TELEPRINTER No II. A & B

TG (L) 1129

TELEPRINTER No II. A, B & C.

TG(L) 1129

FIG. 2. MOTOR SCHEMATIC

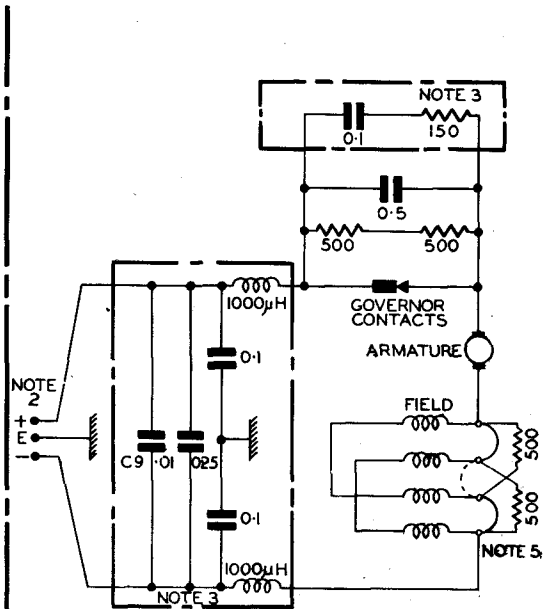
| FIGS. 2, 4 & 6, & NOTE 5, AMENDED, NOTE 7 ADDED. P9 12-50 A | | | | | | | |

FIG. 7. LAYOUT OF BLOCKS TERMINAL, STRIPS CONN., SPRINGSETS AND JACKS AS SEEN FROM BELOW BASE.

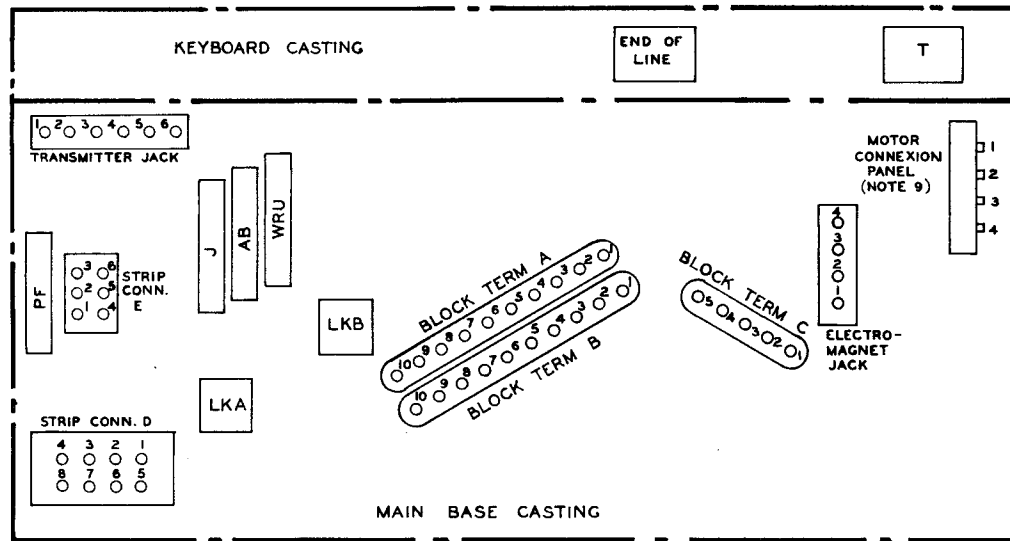
FIGS 2, 4 & 6, & NOTE 5 AMENDED; NOTE 7 ADDED. 29.12.50 A.
 AMENDED TO INCLUDE TPR No 11C. PANEL 5. 15.10.51 B.
 ADDED NOTES RE-ARRANGED & AMENDED.
 FIG.7. LAYOUT OF LNA, LKB AMENDED; NOTE 4 AMENDED. 12.6.52 C.

| | C | FIG.7 LAYOUT OF LKA, LKB AMENDED NOTE 4 AMENDED | W.F.E. | 12-6-52 |
